Special Meeting of the Council

4.1 Application for Review P2044/2018 of Planning Application PL17/027801 for 14 & 16 Clay Drive, Doncaster (Amended Plans for VCAT)

File Number:	IN19/82
Responsible Director:	Director City Planning and Community
Applicant:	Arnwell Pty Ltd
Planning Controls:	Activity Centre Zone, Schedule 1 (ACZ1), Development Contributions Plan Overlay, Schedule 1 (DCP01), Parking Overlay, Schedule 1 (PO1)
Ward:	Koonung
Attachments:	<ol style="list-style-type: none">1 Substituted, Amended Plans ↓ 2 Original Decision Plans ↓ 3 Side-By-Side Comparison of Plans ↓ 4 Detailed List of Changes to Plans ↓ 5 Legislative Requirements ↓ 6 Previous Council Report ↓

Figure 02: Amended Plans

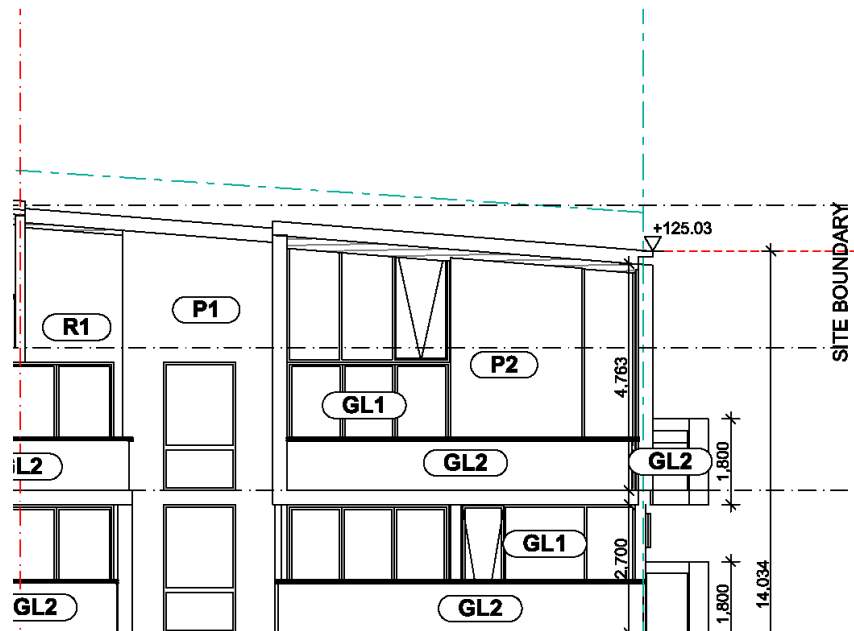
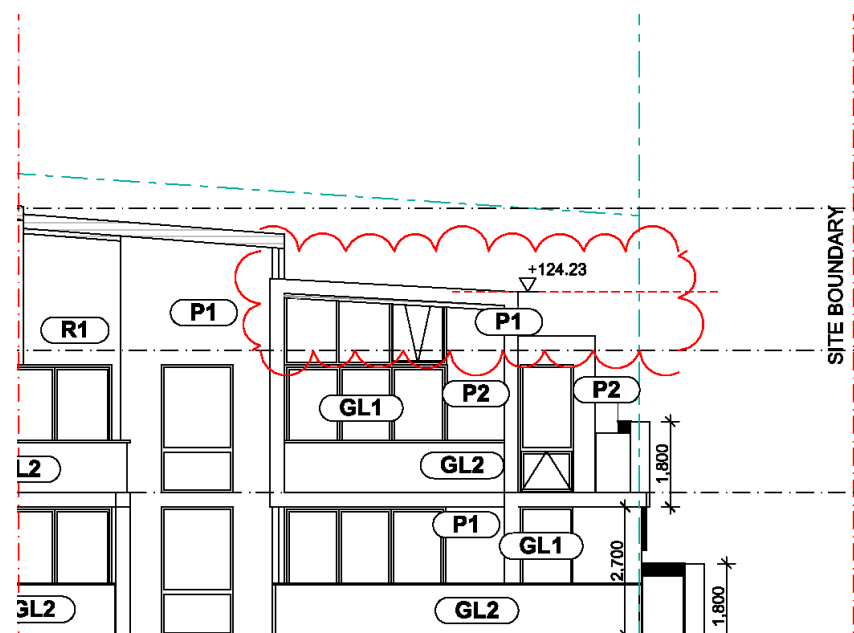
- 8.15 The roof form at the southern side of the building has been modified to a flat roof form, where one continuous roof pitch was previously provided across the entirety of the building. This has allowed a reduction in the design element that frames Apartment 303's western terrace and a subsequent decrease to the building height on the southern elevation (by between 0.84 metres and 1.68 metres) resulting in a building height at the southern end of 12.4 metres (from the previous 14.04 metres). The following images provide a demonstration of the stepping introduced to the amended proposal:

- 8.16 The increase to setbacks to the third floor level walls and terraces at both the southern and western elevations creates a recessing from the levels below where previously a sheer wall presentation was observed. This results in a notable reduction in visual bulk and evident transition in building form to the southern elevation when viewed from both the streetscape and the adjoining property to the south.
- 8.17 Importantly, the resulting built form on the southern elevation is of a scale and design that would provide a suitable built form transition to the form of development anticipated within Sub-Precinct A of the DDO8.

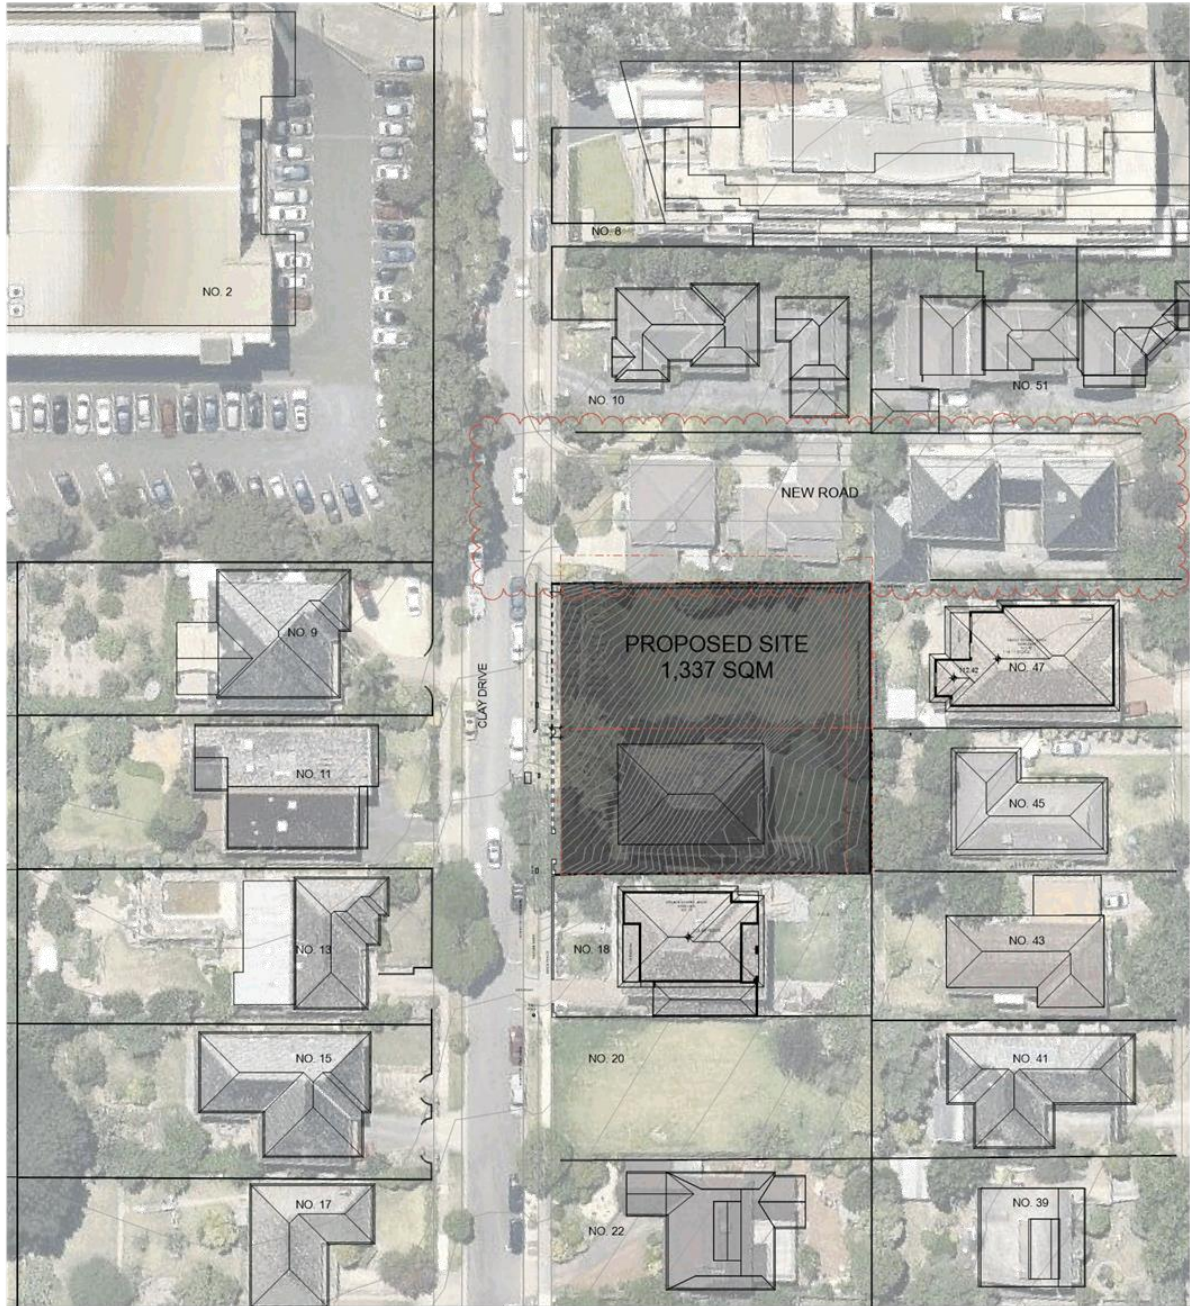
The proposal does not provide adequately detailed visibility splay requirements along the exit lane at the site frontage and has not fully considered crossover width or location impacts on street trees, which is contrary to Design Standard 1 (Accessways) at Clause 52.06-9 (Car Parking) of the Manningham Planning Scheme.

- 8.53 The proposal originally failed to detail visibility splays on the ground floor plan to demonstrate adequate site lines when exiting the basement. The amended plans adequately detail visibility splays in accordance with Design Standard 1 of Clause 52.06 Car Parking of the Scheme.
- 8.54 It is noted that the location of the crossover has not changed and will require removal of a mature street tree. Considering the topography of the land, the crossover has been sited in the most logical location for basement access, at the lowest point of the land. On balance, removal of a street tree to accommodate a development of this nature is an acceptable outcome subject to replacement planting.

SECOND FLOOR PLAN
Key Changes:

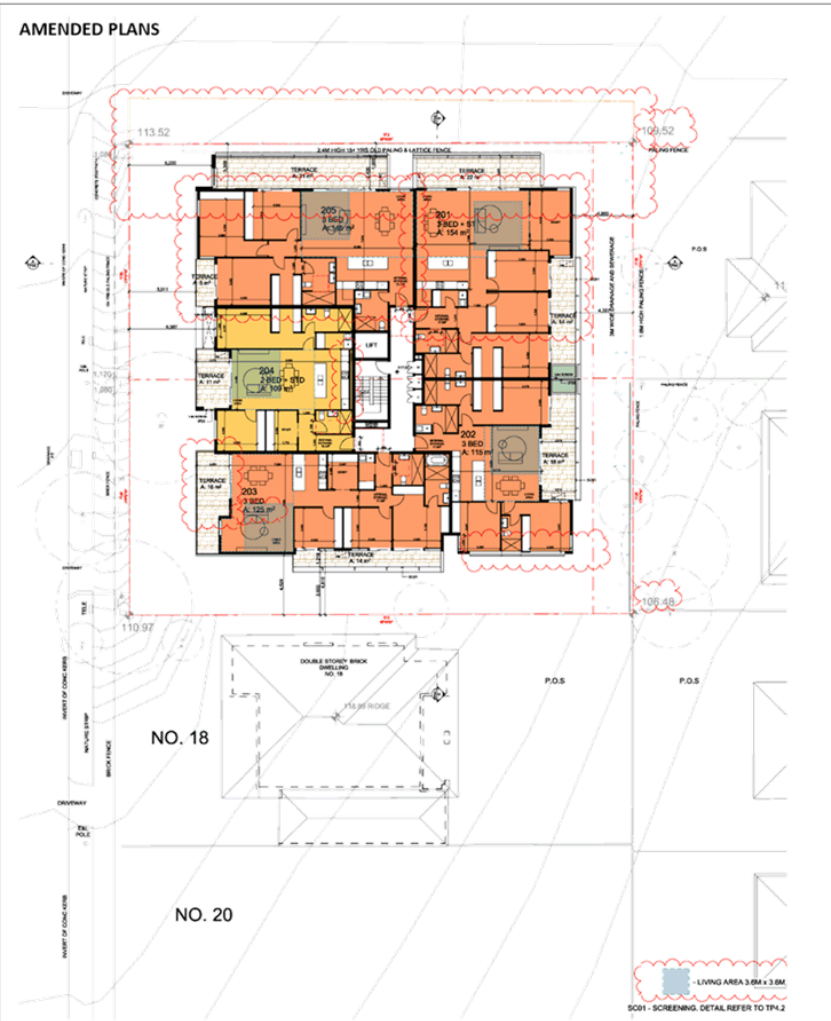
- Reorientation of the building further north, reducing the northern boundary setbacks
- Reconfiguration of apartment rooms and layouts

THIRD FLOOR PLAN
Key Changes:

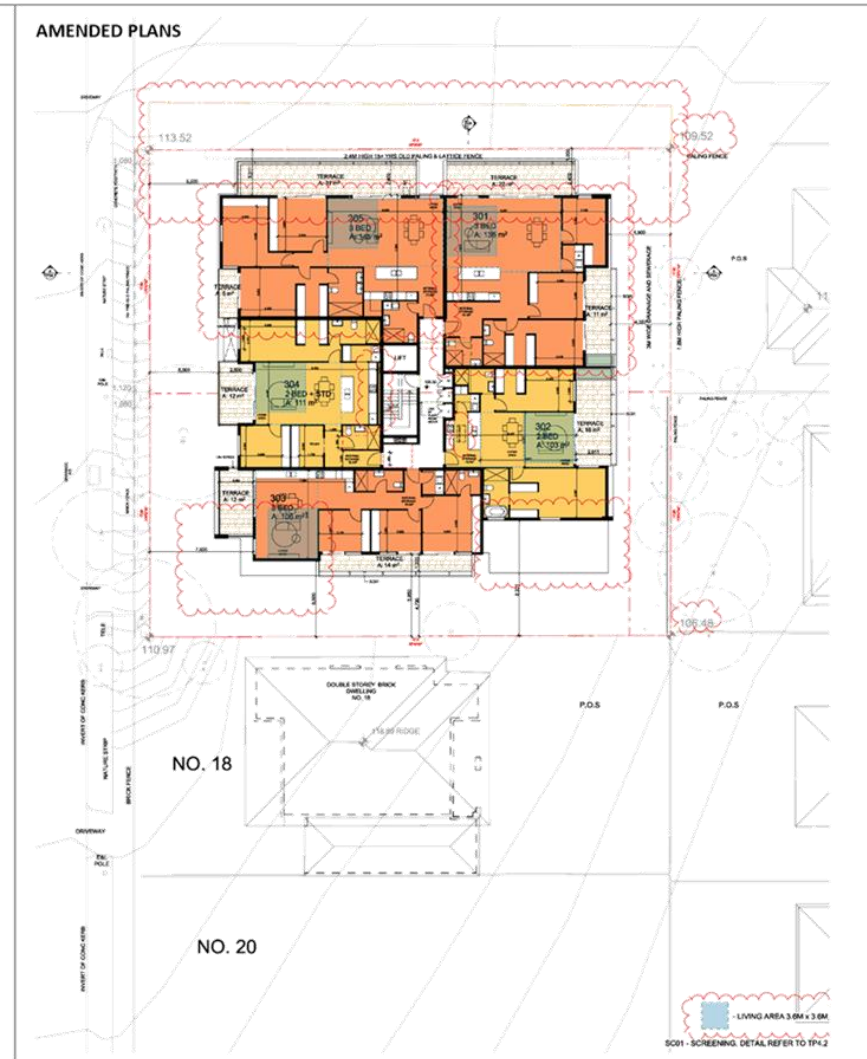
- Reorientation of the building further north, reducing the northern boundary setbacks
- Reconfiguration of apartment rooms and layouts

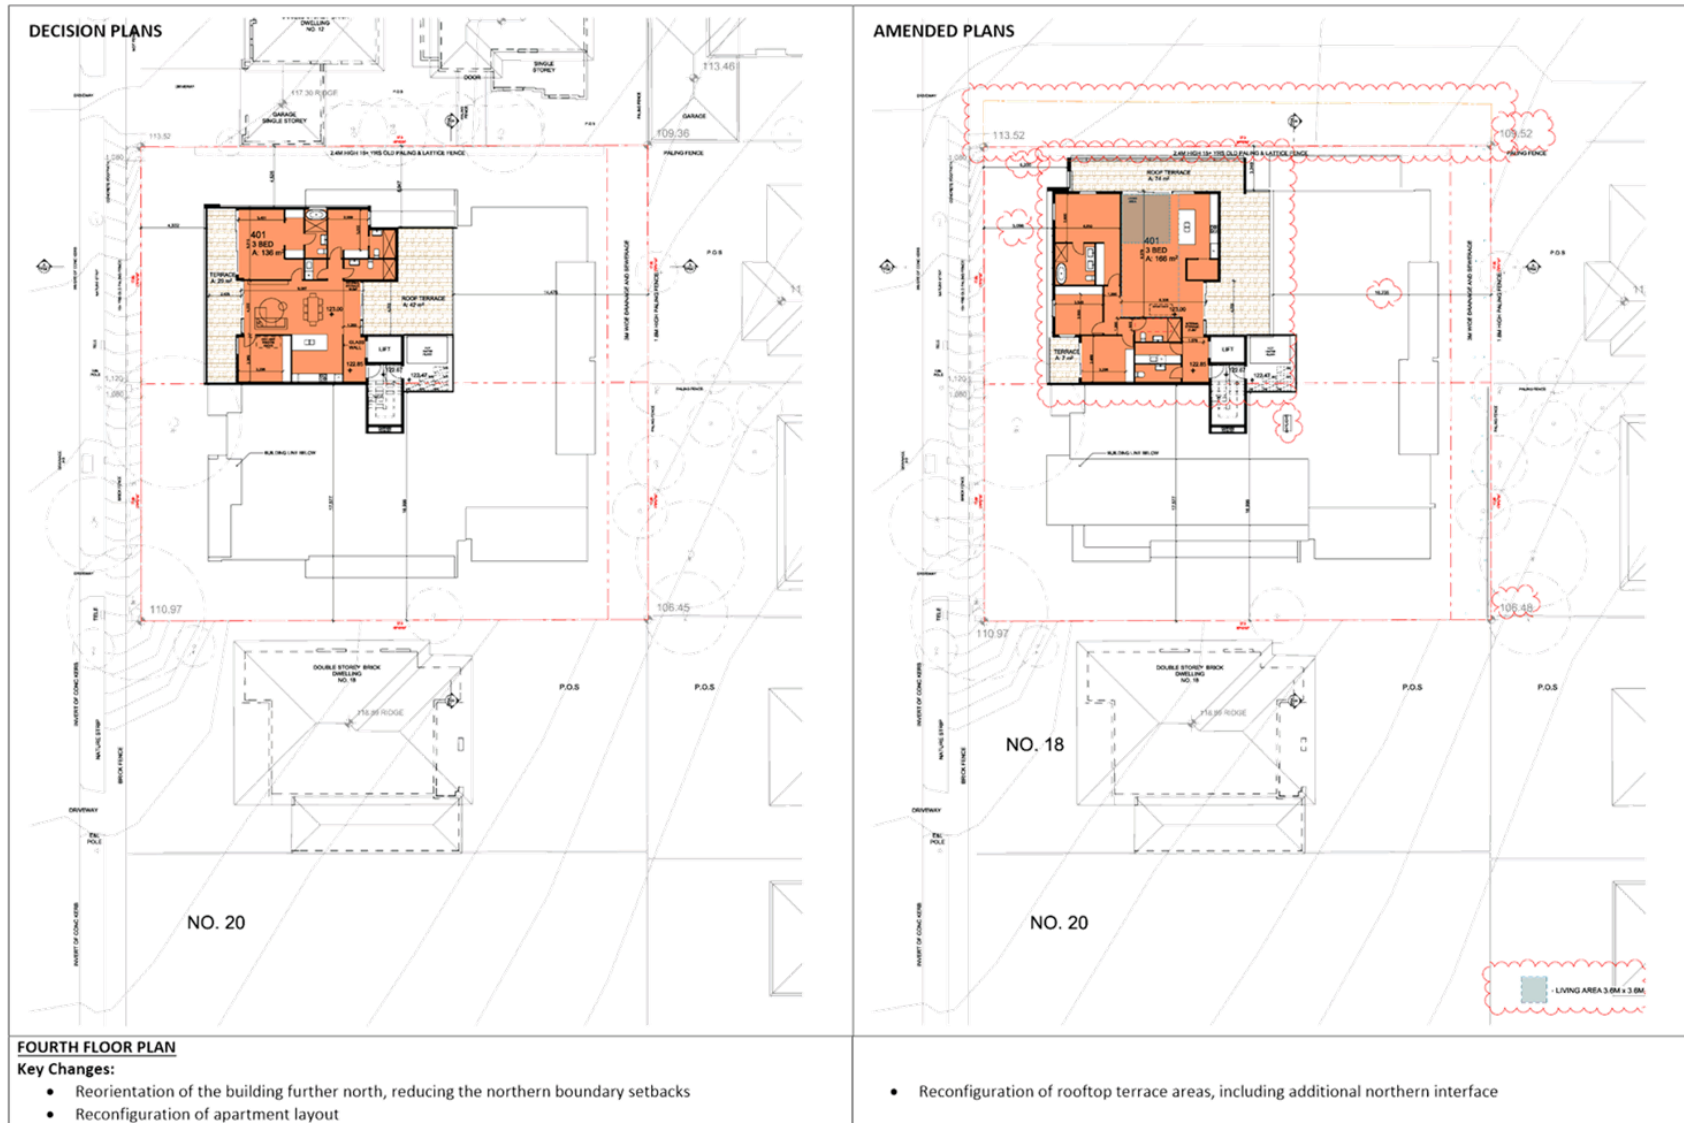
- Increase to setbacks on the southern elevation through reduction in the building footprint
- deletion of terraces on the southern elevation and addition of terraces on the northern elevation

DECISION PLANS

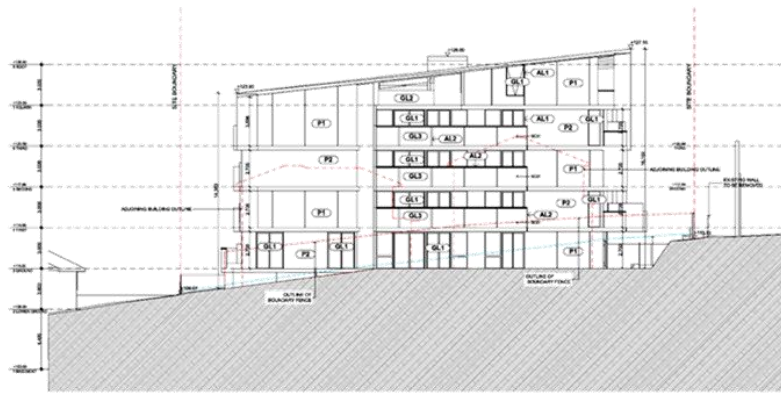
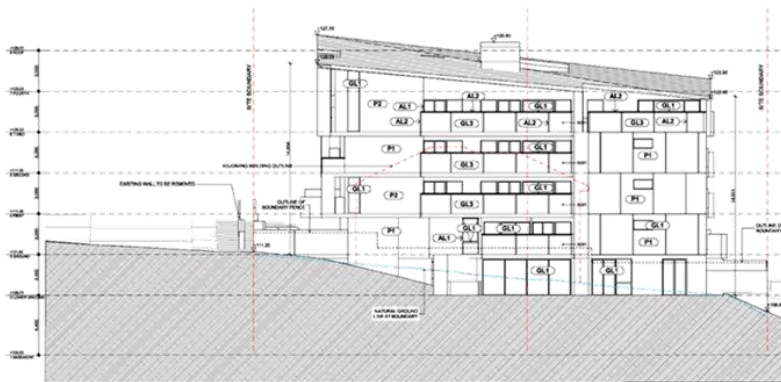
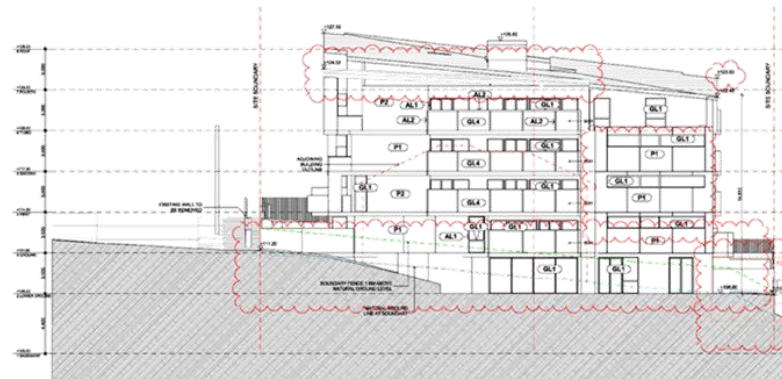
- Reconfiguration of the roof form and feature design elements
- Alteration of terrace and window locations
